SMALL ARROW ENGINEERING, LLC

EMW Public Access CNG Station Moriarty, New Mexico Addendum Number 1

Date: September 2, 2020
Issued to: All Bid Document Holders of Record

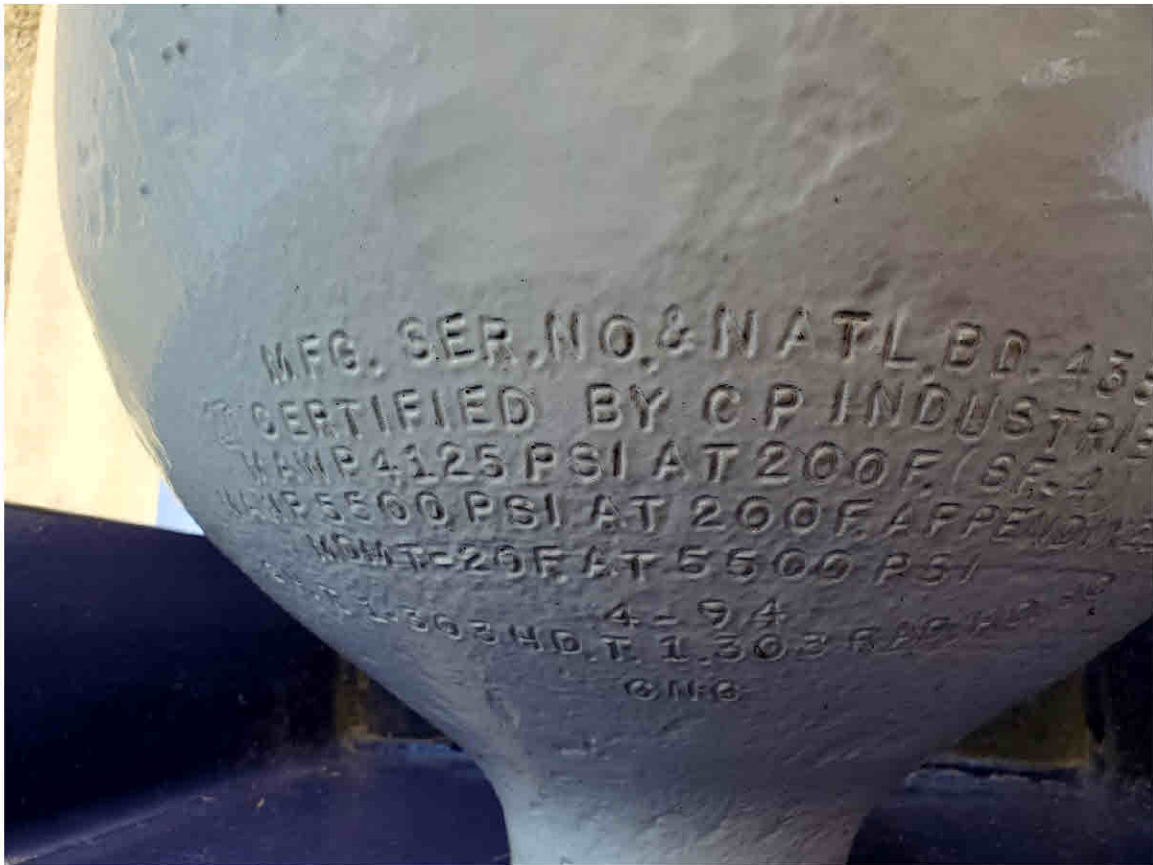
1. Reconditioning CNG storage Cylinders. These were not on site for inspection. Please provide direction on exactly what needs to be done to recondition these units. **EMW will transport the vessels to the Moriarty Shop for the Contractor to refurbish. The vessels will need to be sandblasted and painted with matching colors of JW sphere skids. The vessels will also need new relief valves installed with 3 year certification for 5500 psi setting.**
2. Are pictures available? **YES, see attached below: (And digital images are available upon request.)**

SHEET: 2 OF 27

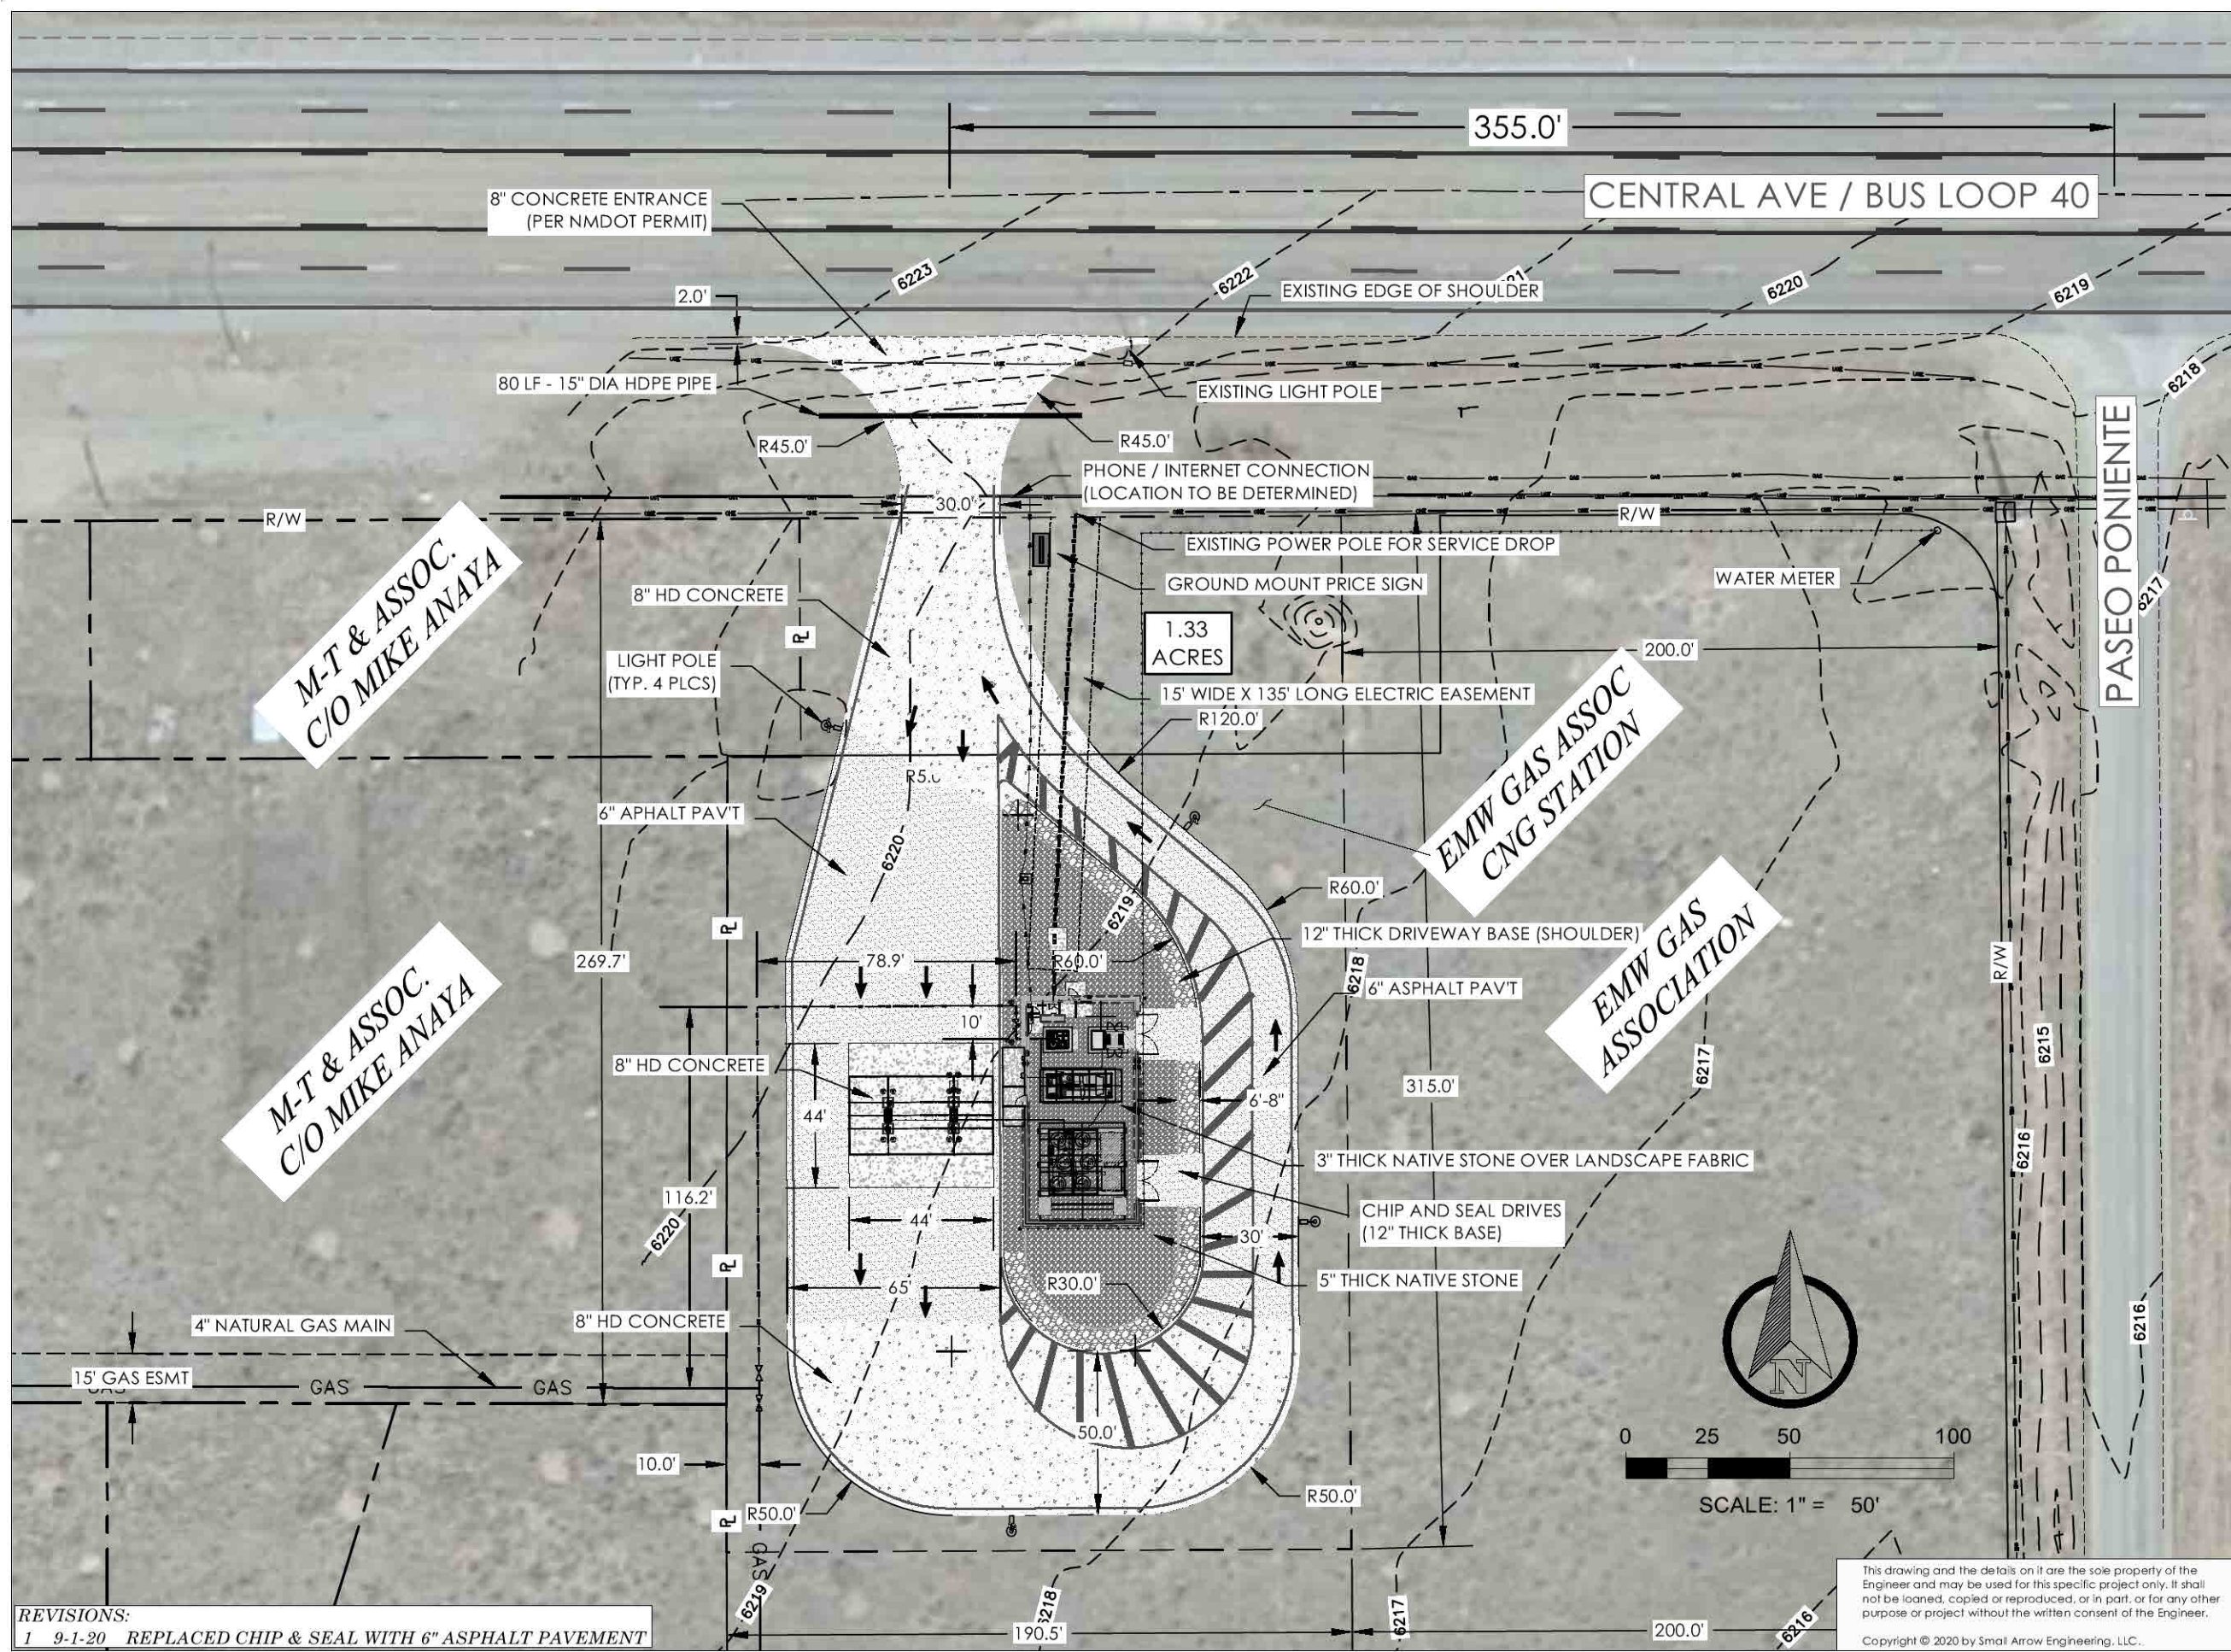
2. Please provide details for the chip and seal (w/12" base). If asphalt is acceptable as an alternate, please provide details. **Yes, Asphalt will be acceptable. We have replaced the Chip & Seal option with Asphalt. There is now a detail on Sheet 10. There is also an alternate bid item added to the Bid Form for using all asphalt paving except the concrete fueling pad under the canopy.**

3. Please provide details for 8" HD concrete paving. **There is now a detail on Sheet 10.**
4. Is the NMDOT permit and its requirements relating to the concrete entrance available? **Not at this time.** Please provide copy of the NMDOT permit drawings referred to on sheet 2? **Use typical sections now available on Sheet 10.** Unit price sheet lists details #13,15,16 & 31 referring to NMDOT not shown on plans? **Use details on Sheet 10, Refer to NMDOT Standard Specifications for gradations. Also, please refer to NMDOT Standard Drawing 702-05-1/1 "INSIDE / MEDIAN AND OUTSIDE LANE OPERATIONS FOR DIVIDED INTERSTATES & NON-INTERSTATES" for traffic control measures required for lane closure along Business Loop 40.**

5. Can you confirm the HDPE drainage pipe is to be 18" instead of 15"? Are any details on the install of this drainage pipe? **15" Pipe installed per manufacturer's specifications.** What kind of ends are required? **No End Treatments are required.**

PROJECT: PUBLIC CNG STATION
 SHEET DESC: WALL & SIGN ELEVATIONS
 SHEET: 5 OF: 27

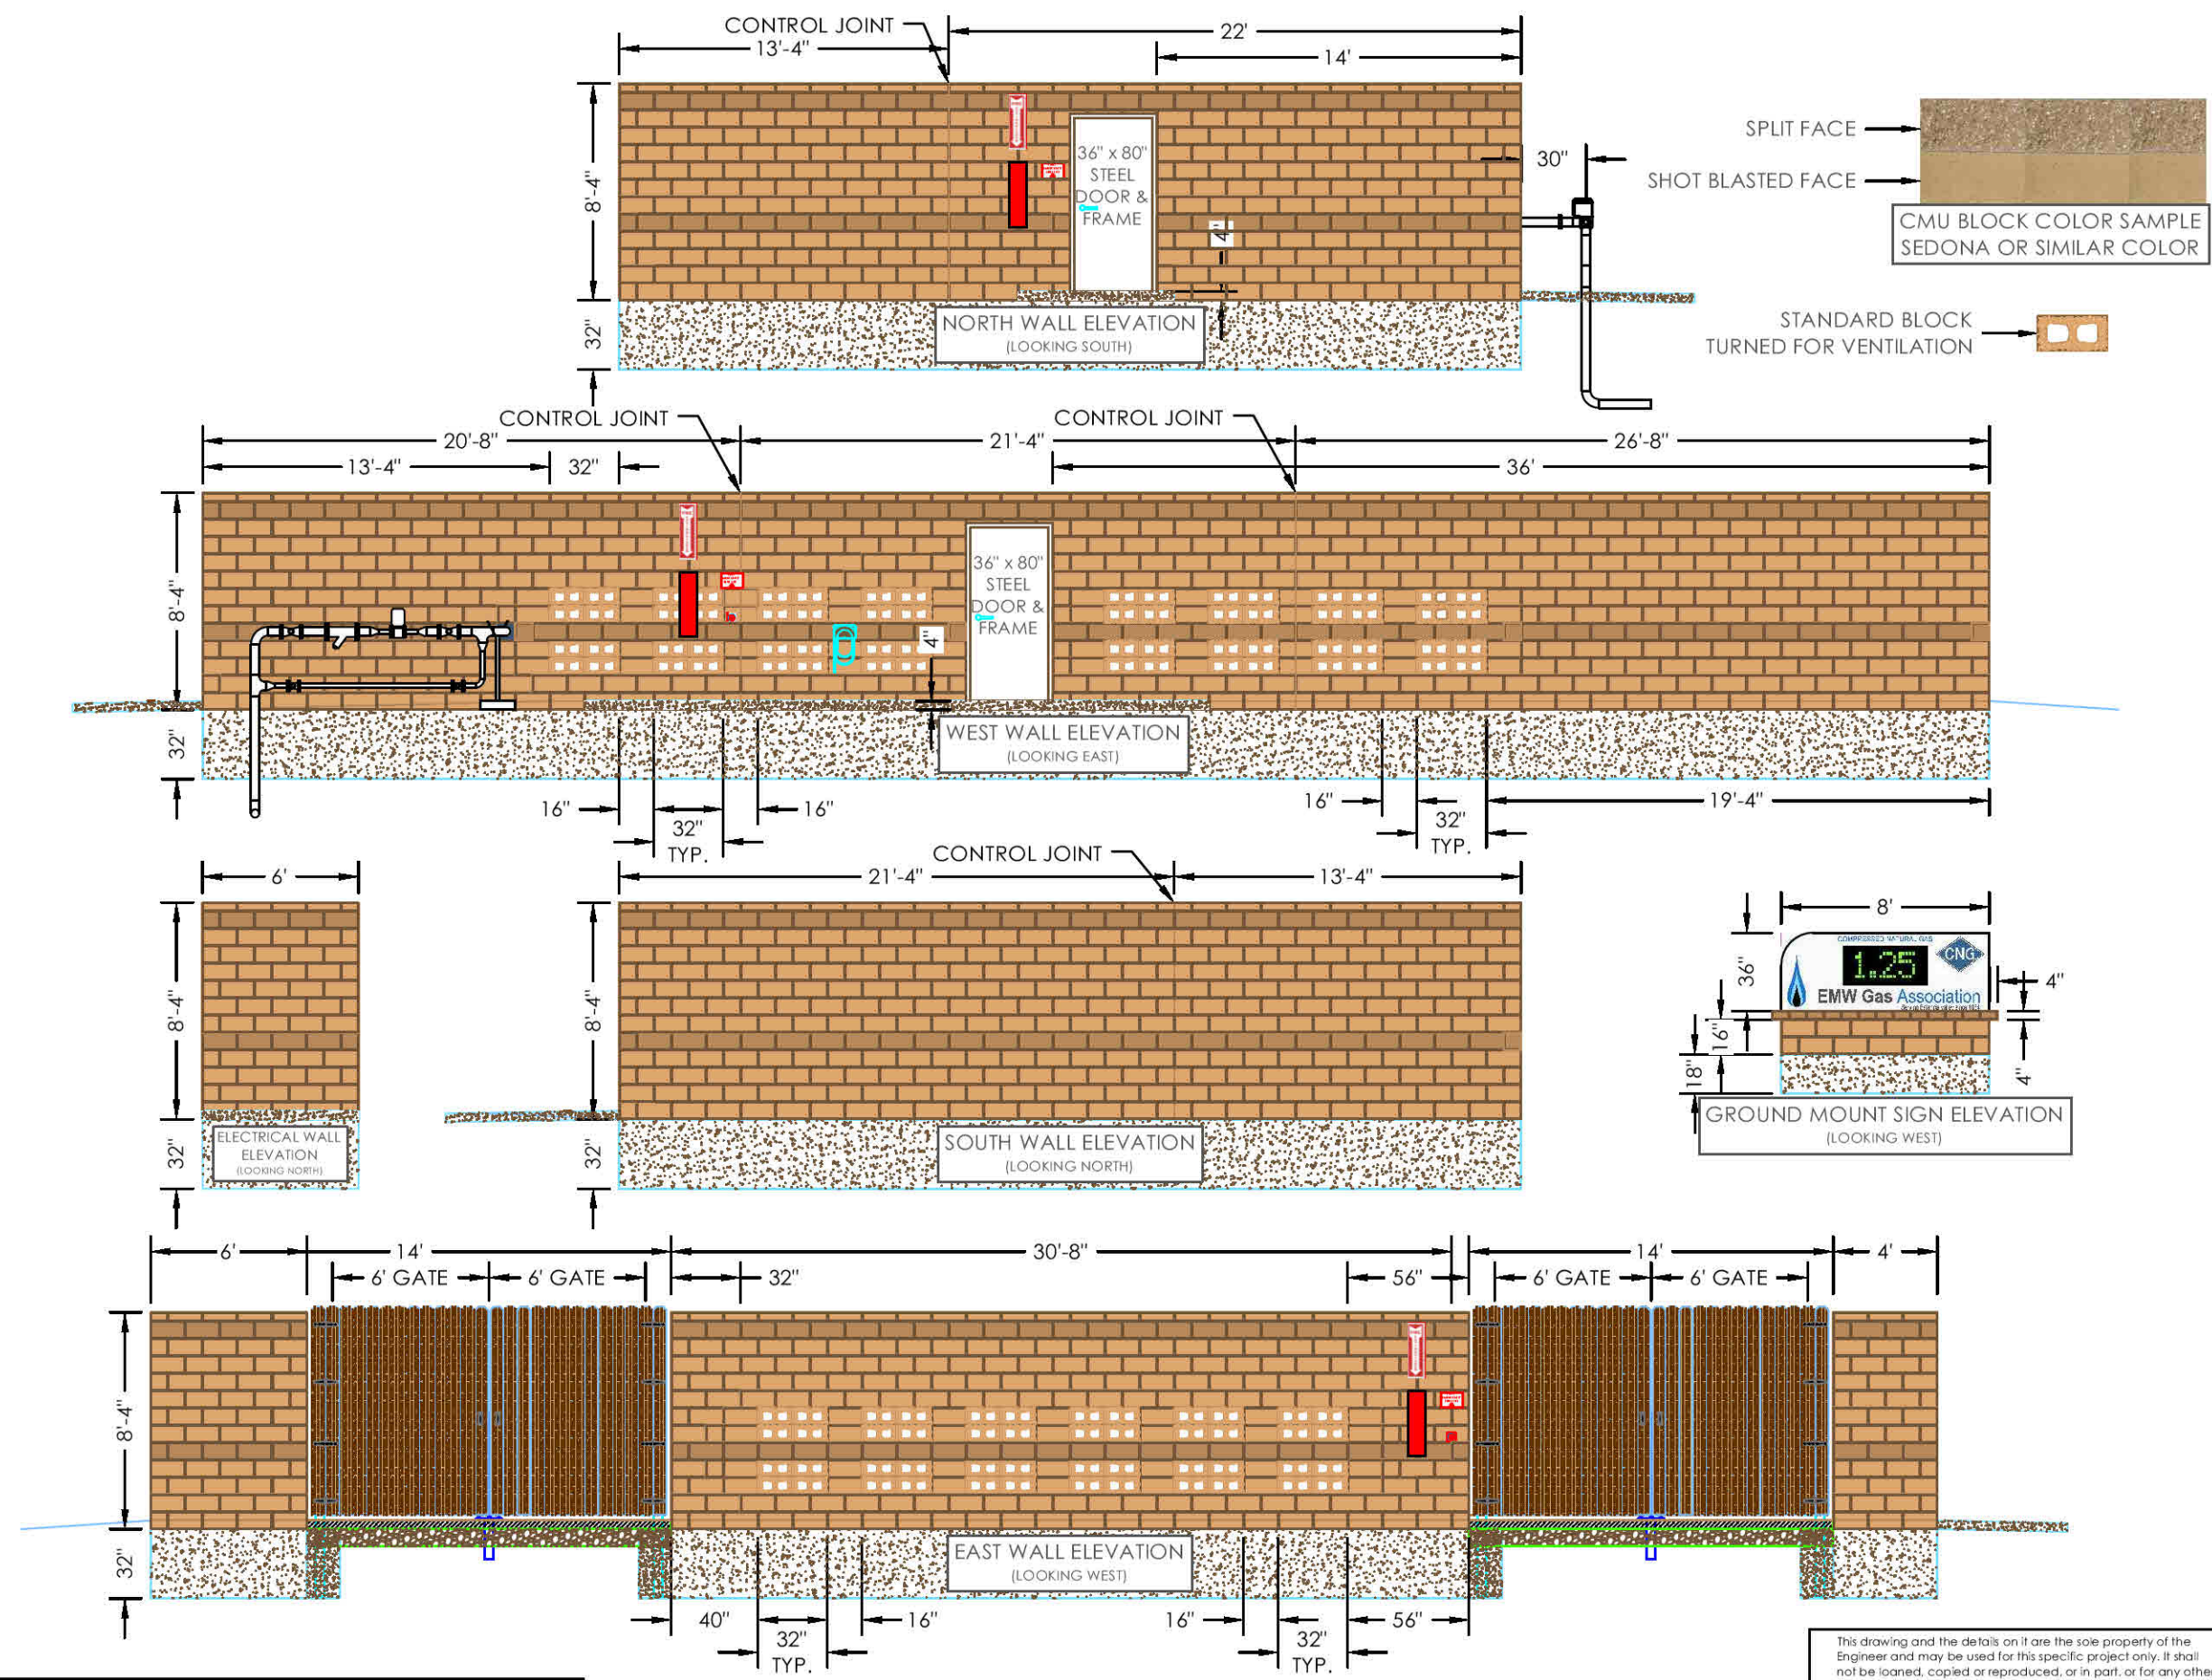
1. CMU Block - Desert Rose is no longer available and the 6x12x12 sunflower is out of stock, Utility Block no longer makes any block with pumice and that is what designates the finish color. Pumice is the white aggregate, they now use scoria which is red. **Please see revised Sheet 5. Color is now Sedona or similar color. Venting blocks are now standard blocks turned on their sides.**

REVISIONS:
 1 9-1-20 REVISED BLOCK COLOR, VENTILATION BLOCK, PATTERN
